RE: Followup Photos - input needed

Stephen Stein
Deputy Regional Chief - Western Pacific Region
Office of Aviation Safety
National Transportation Safety Board
32125 32nd Ave S, Suite 140
Federal Way, WA 98001
[REDACTED]

Screenshot 2025-12-01 085920.png;

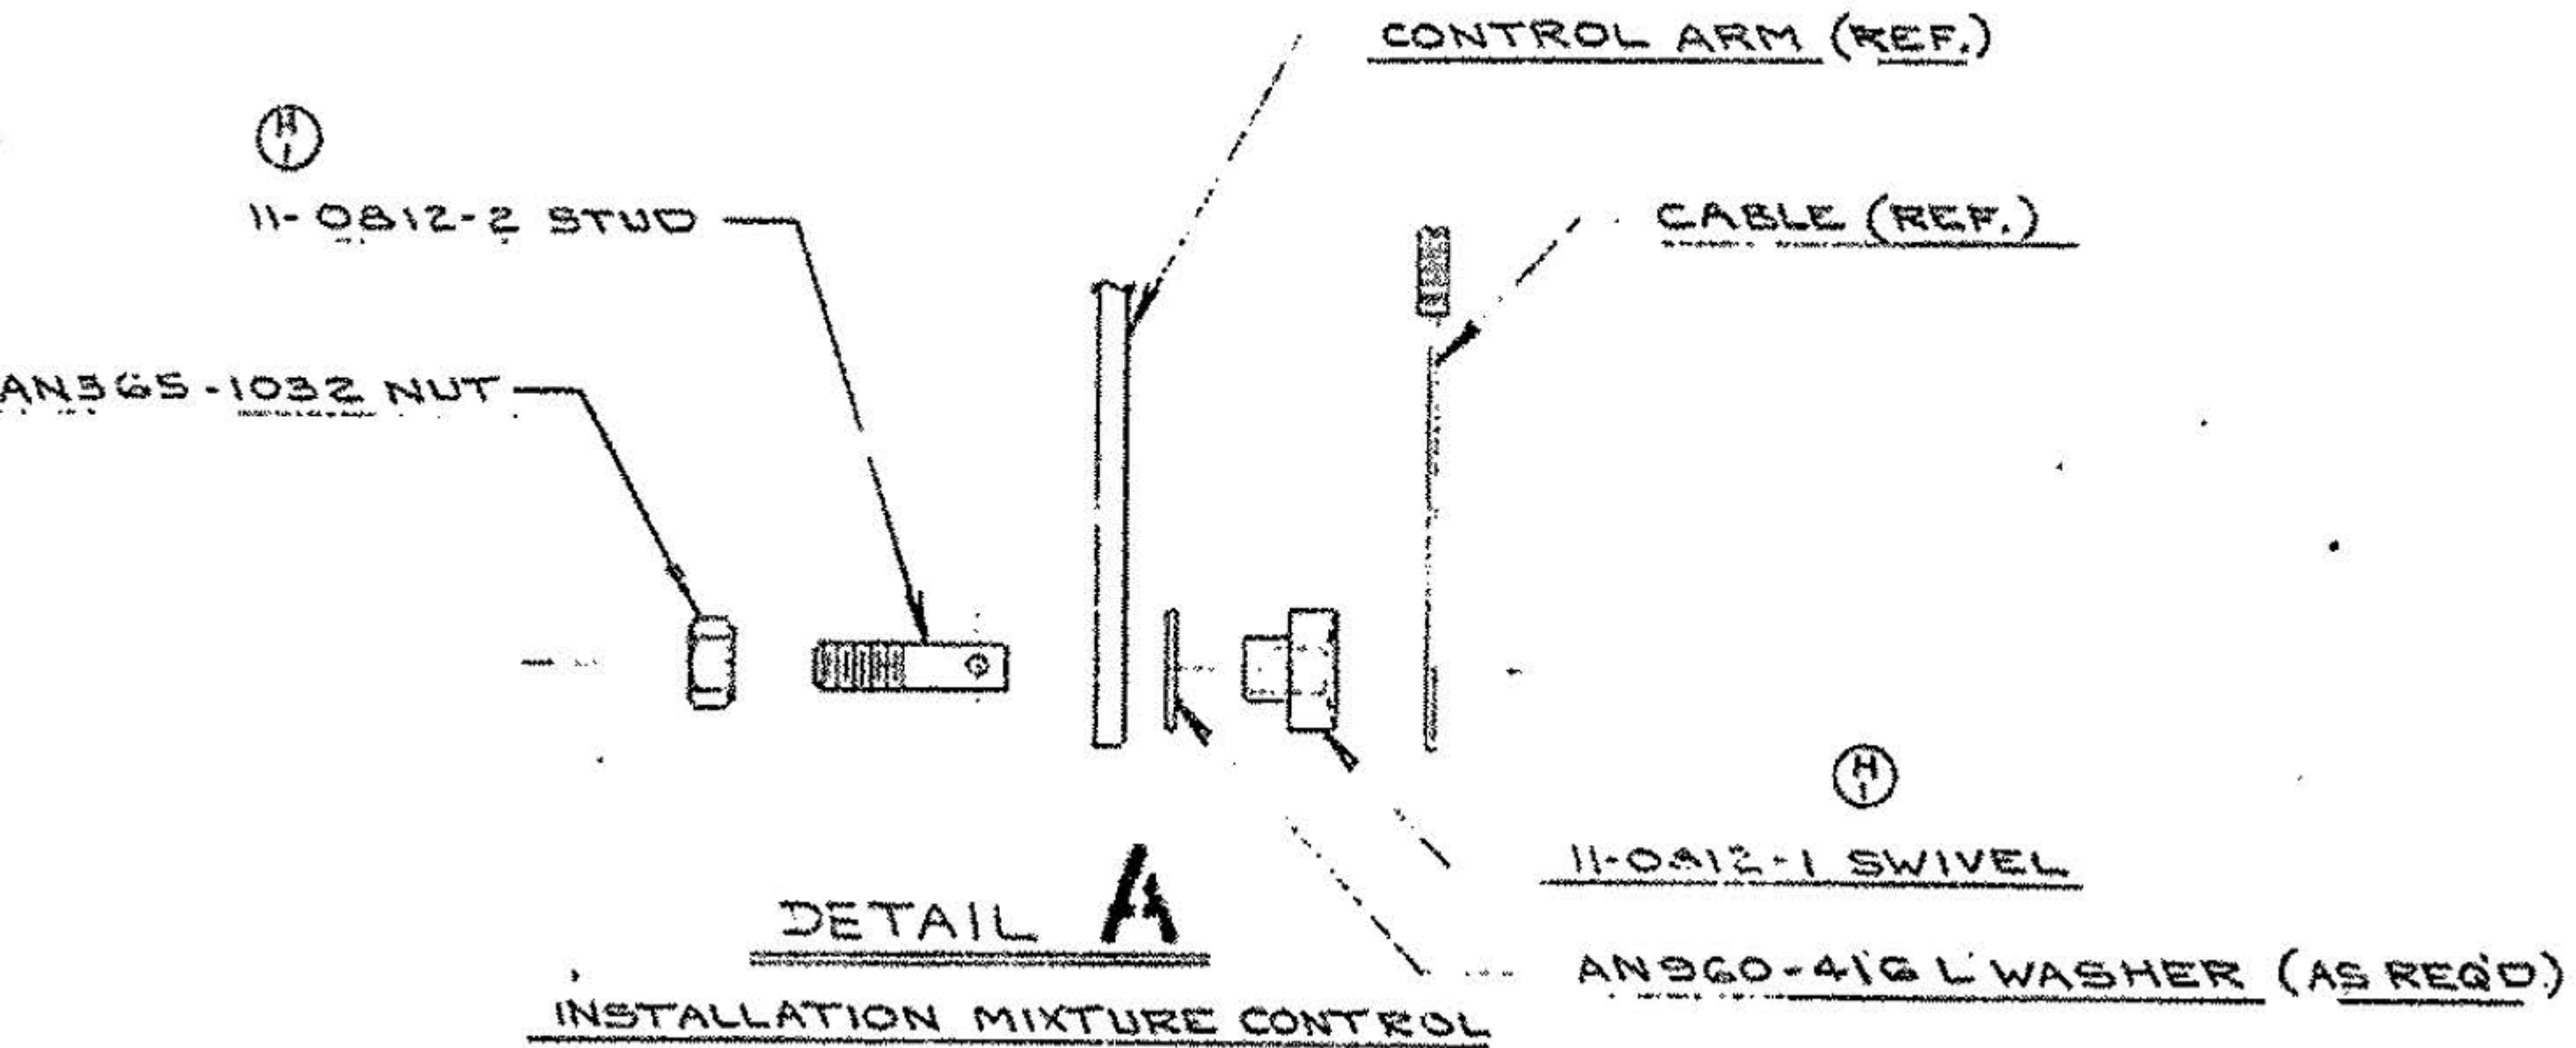
Hi Jerry - one question - the two bolts crushing the cable is from the pic below correct (I believe this is at the mixture control arm of the carb)? I'm wondering what the swivel design looks like.

Yeah, the first one was all I needed. We cant find that set up in the type design.
It looks like 2 washers crushing a loop on the cable.

They type designs have a 'swivel' function that lets the cable rotate in order to have mostly a tension/compression in the cable. This does not.

What you will see is that the broken mixture cable is work hardened and failed (i.e. fatigue) because its constantly being bent...when the intent is pushing and pulling not bending

It uses a bushing and the bolt shaft is more like a pin so it can rotate in the assembly
